MEETING NOTES
Waste Management Area C RCRA Facility Investigation Report

MEETING DATE: April 21, 2016

BACKGROUND INFORMATION: The meeting was called to promote continued Ecology, EPA, DOE, and WRPS discussion about comments associated with and revision of RPP-RPT-58339, Rev. A Draft *Phase 2 RCRA Facility Investigation Report for Waste Management Area C* (WMA C RFI Report). The report was submitted to Ecology and EPA in December 2014 to meet *Hanford Federal Facility Agreement and Consent Order* (HFFACO) Milestone M-045-61. Ecology's February 23, 2015 response to the RFI report submittal (Letter 15-NWP-37) noted that holding "a recurring meeting to discuss statements, regulatory interpretations, and the process steps for obtaining an agreeable RFI/CMS process for WMA C Closure" would be beneficial. Ecology comments on the WMA C RFI Report and supporting documents were transmitted on July 7, 2015, "Department of Ecology's (Ecology) Completed Review of Phase 2 RCRA Facility Investigation Report for Waste Management Area C, RPP-RPT-58339, Revision A Draft" (15-NWP-120).

Figure 3-1: Human Health Conceptual Exposure Model

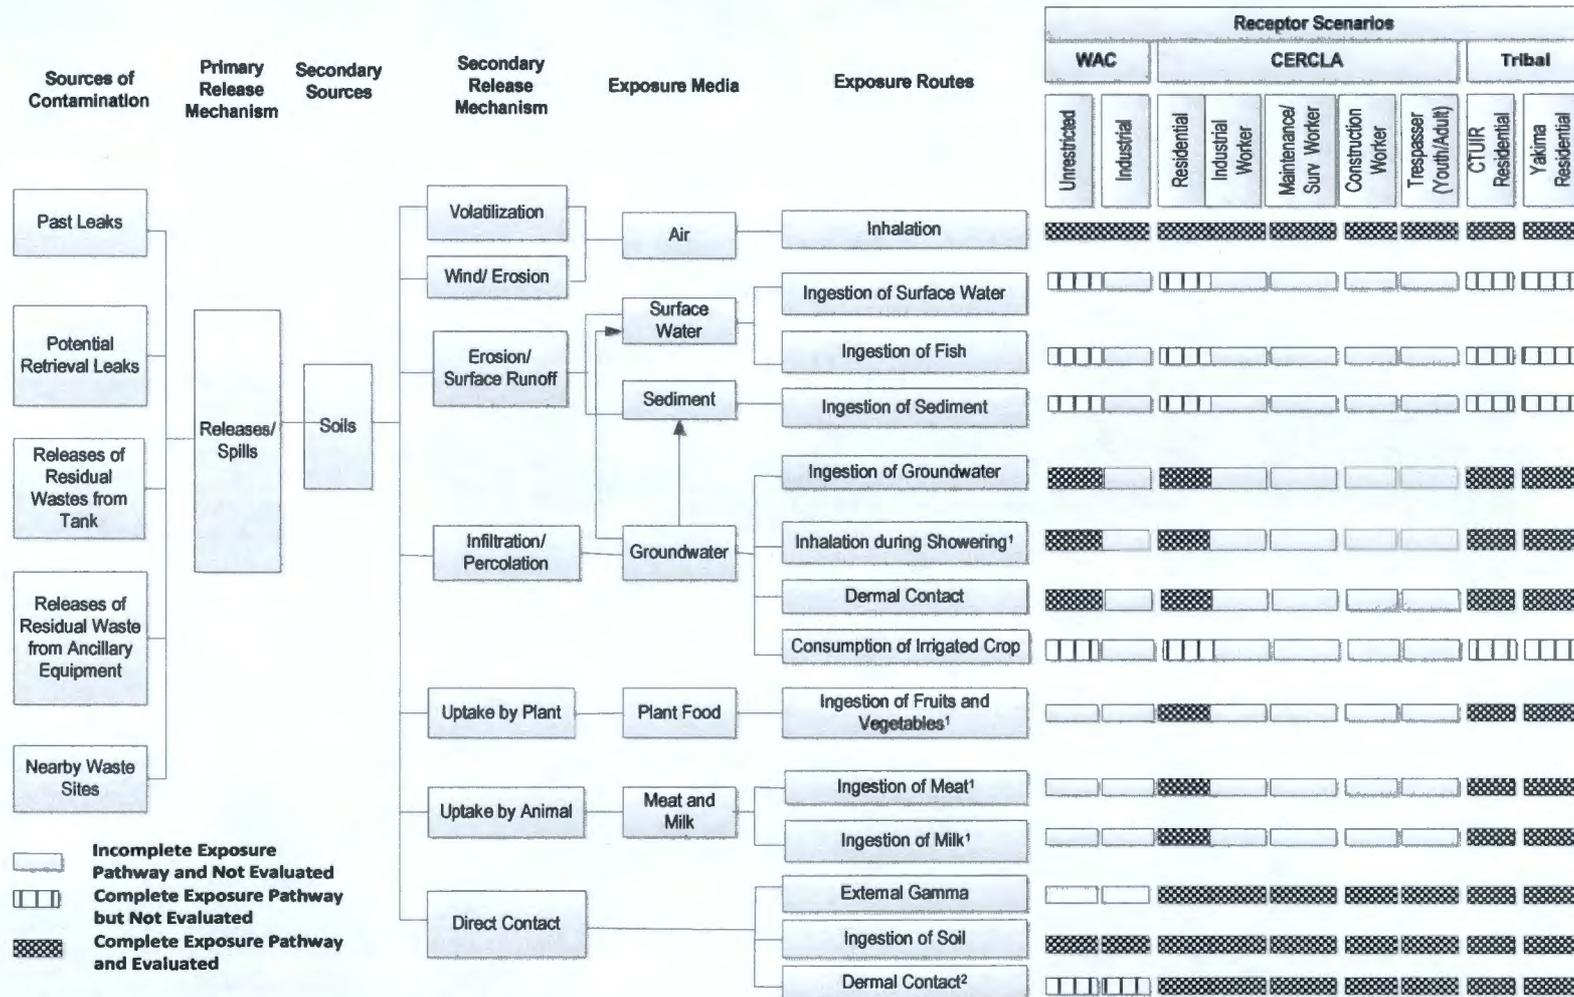
Damon BRA 12: Tentatively Agreed Pending Modification. Dr. Delistraty tentatively agreed to the proposed revised response, pending modification to BRA Figure 3-1 and incorporation into the

revised BRA. The figure should be modified to delete the superscript "1" from the exposure routes for ingestion of fruit, vegetables, meat, and milk. Superscript "1" should remain for the exposure route for inhalation during showering. The figure should also be modified to add a superscript "2" to the pathway for dermal contact coming out of the groundwater exposure medium.

Commenter	Item	Page #/ section # Line #	Comment & Basis/Justification	Doc	Chapter(s)	Response
Damon	12	P 3-9, Figure 3-1	<p>For transparency, Figure 3-1 should be labeled as human health conceptual exposure model and should present all exposure pathways (even if all are not evaluated). Therefore, in addition to soil ingestion and soil inhalation, MTCA (WAC 173-340) includes soil dermal contact and soil contaminants leaching to groundwater with subsequent ingestion of groundwater by residential receptors. Also, CERCLA includes soil contaminants leaching to groundwater with subsequent ingestion of groundwater by residential and tribal receptors or other subsequent uses (e.g., showering, irrigation of crops). Contaminated groundwater may also impact fish in the Columbia River which may be consumed by residential or tribal receptors.</p> <p>Email from Damon Delistry on 2/18/16, Subject Re: Updated BRA and RFI/BRA comments <i>Damon BRA 12</i></p> <p>The updated Figure 3-1 should be titled, "Human health conceptual exposure model." Footnote 2 applies to nonrad COPCs (not rads). Also, add contaminants transported from groundwater to surface water and sediment with subsequent ingestion of contaminated surface water, sediment, and fish by the WAC resident (unrestricted land use), CERCLA resident, and tribal receptors.</p>	BRA		<p>Figure 3-1 will be revised. The title of the Figure 3-1 will be labeled as "Human Health Conceptual Exposure Model"</p> <p>Three types of exposure pathways - (1) Complete and Evaluated; (2) Complete, but not Evaluated; and (3) Incomplete, hence not Evaluated will be included in the updated Figure 3-1. The pathways listed in the comments will be included as completed by not evaluated. Text will be updated to state the reasoning for not evaluating those completed exposure pathways.</p>
